AMENDMENT TO THE DRAWINGS

FLASHLIGHT AND COMBINATION FOR USE IN
ALIGNING FLASHLIGHT LAMP BULBS
INV: A. MAGLICA
DKT: 728256-100/119
ANNOTATED SHEET SHOWING CHANGES

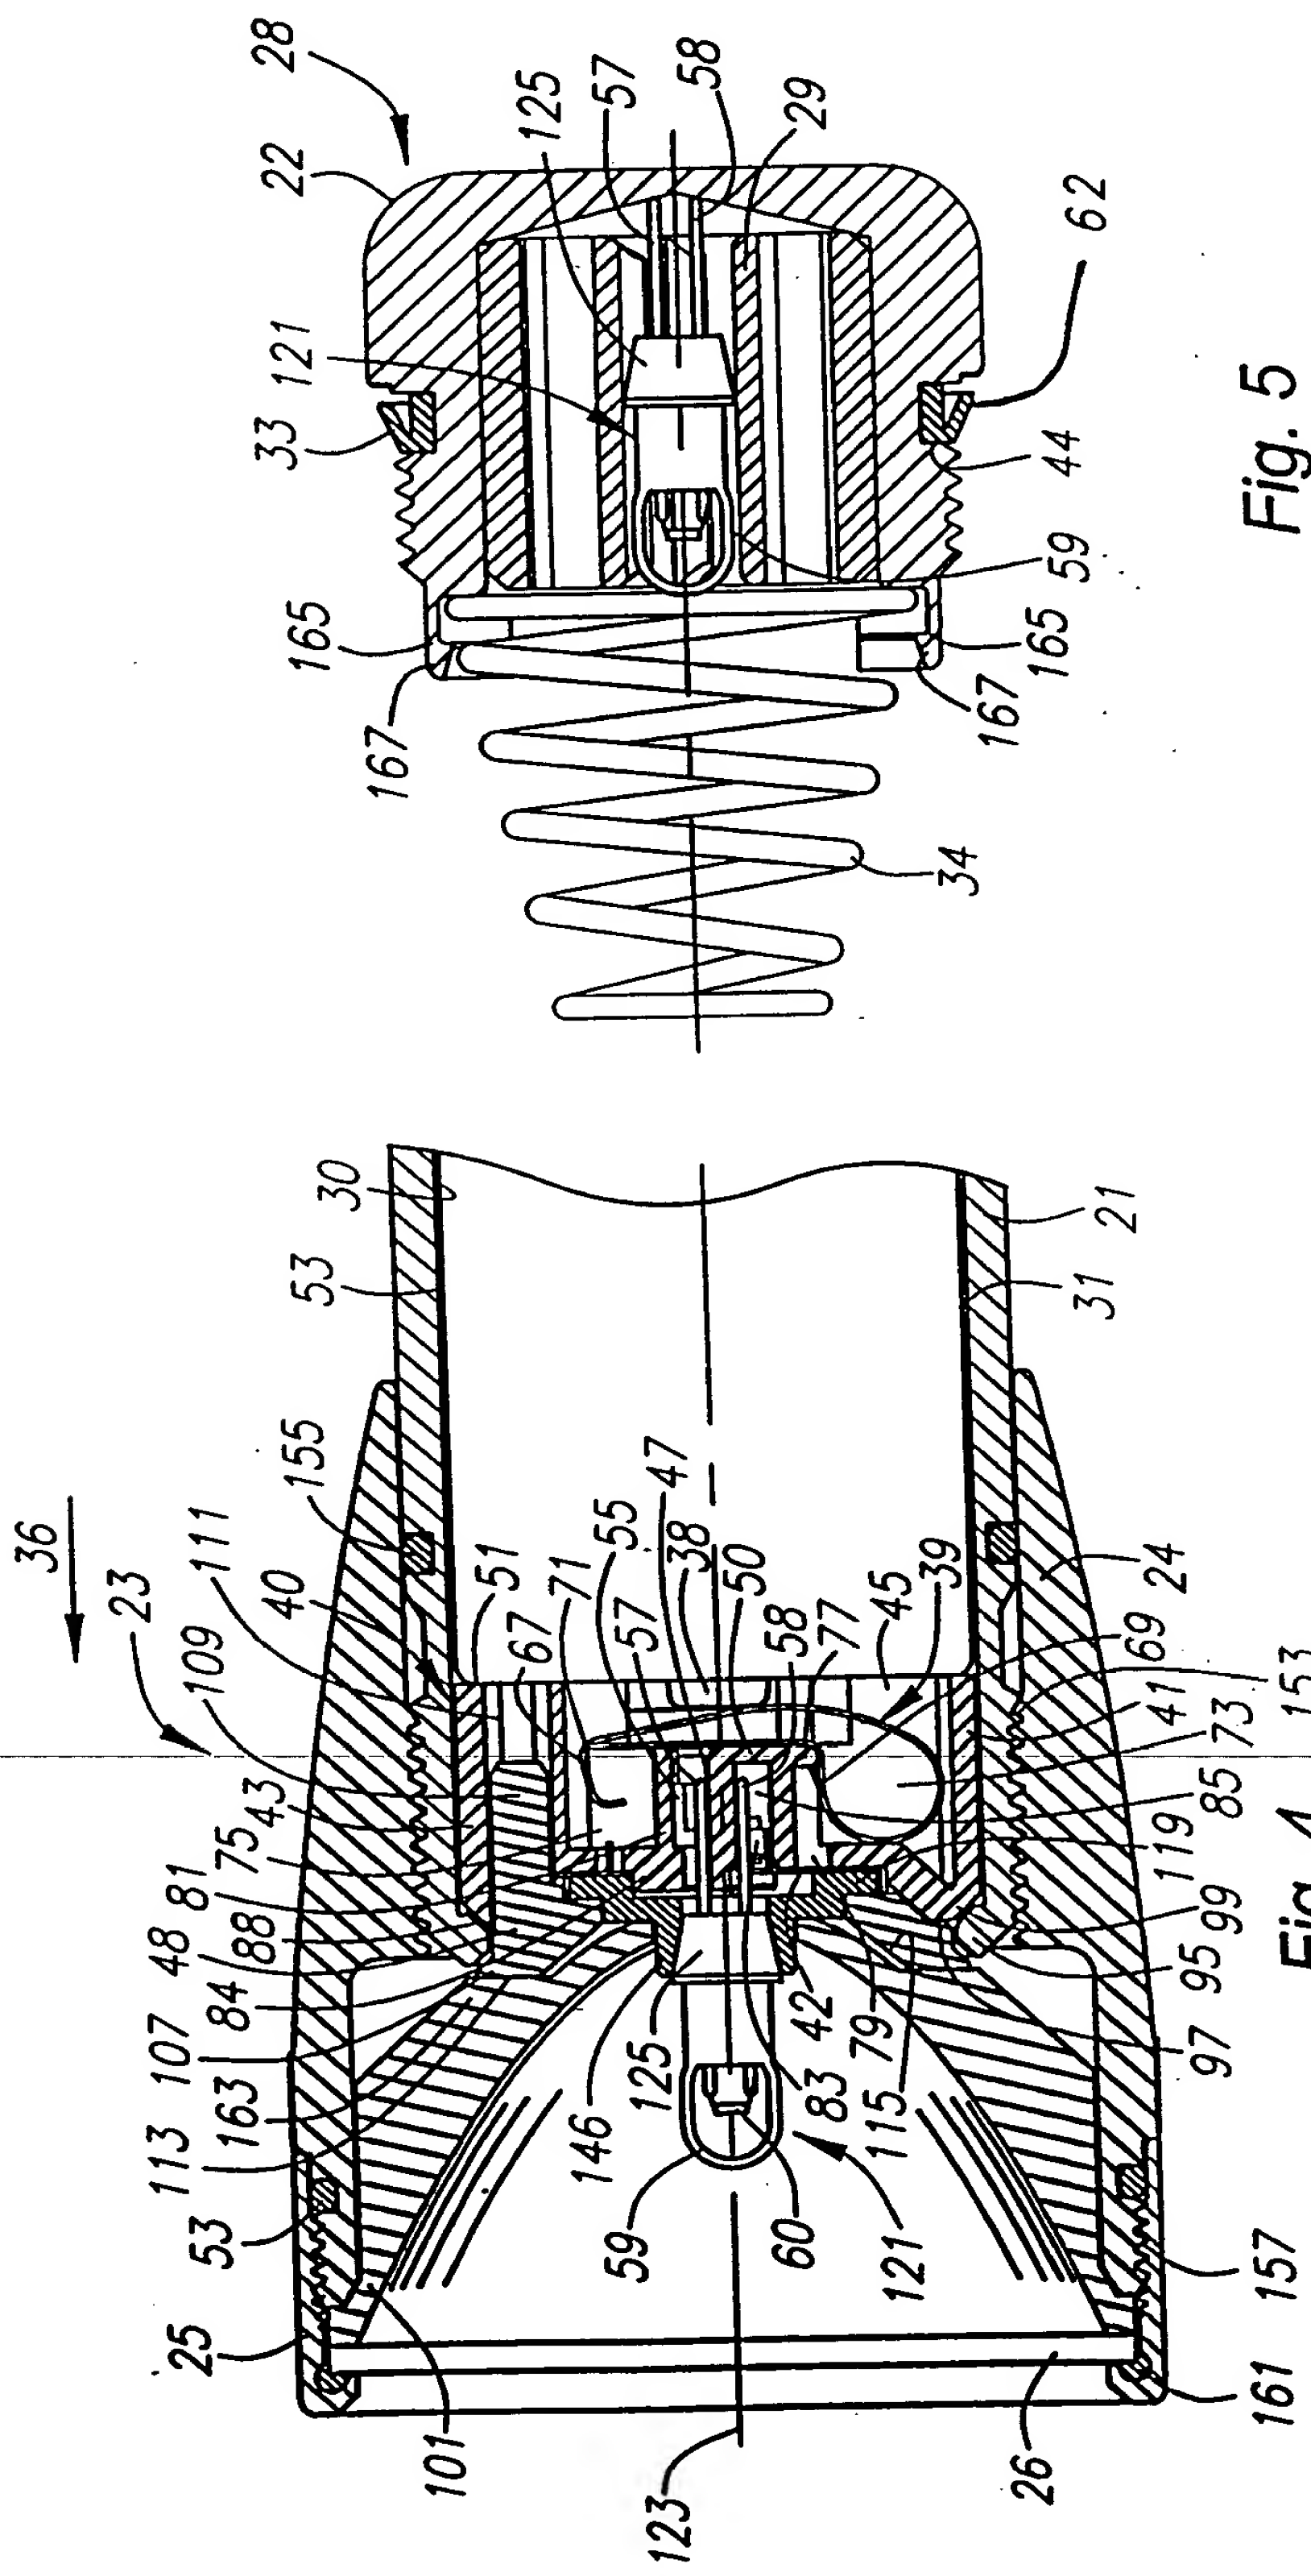
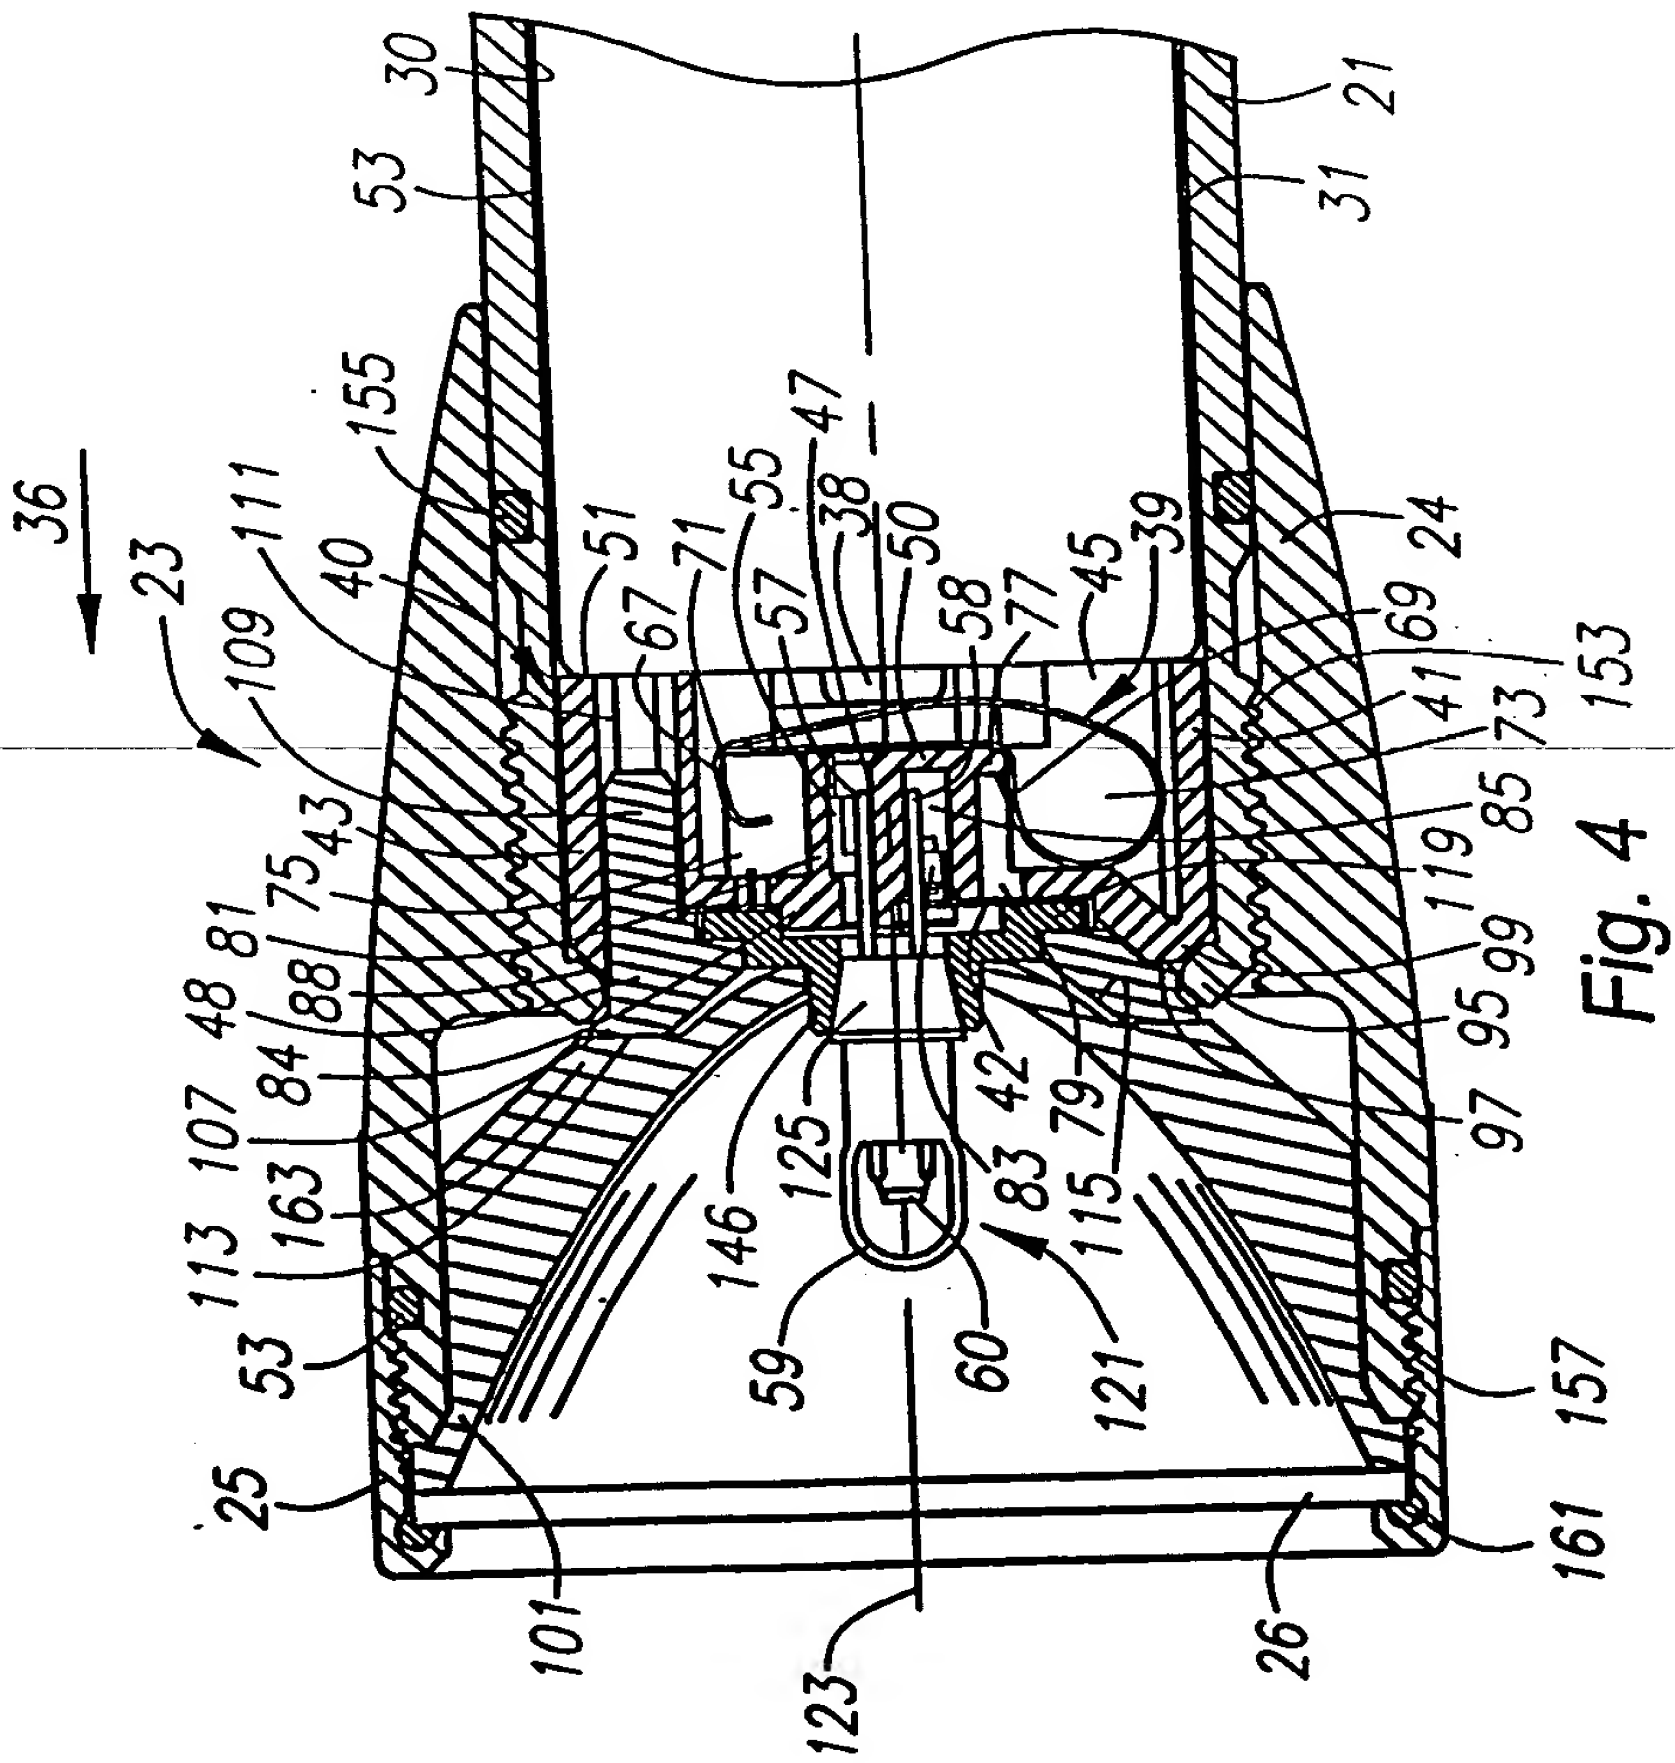
Replacement sheets 02/06, 03/06 and 04/06 replaces original sheets of drawings having the same sheet number. In each of amended Figs. 3, 5 and 6, a new element number character 62 is added to identify the "one way valve" that is disclosed in the body of the specification. The support for this amendment can be found in the specification, for example, at paragraph numbers [0041]. Therefore, no new matter has been added.
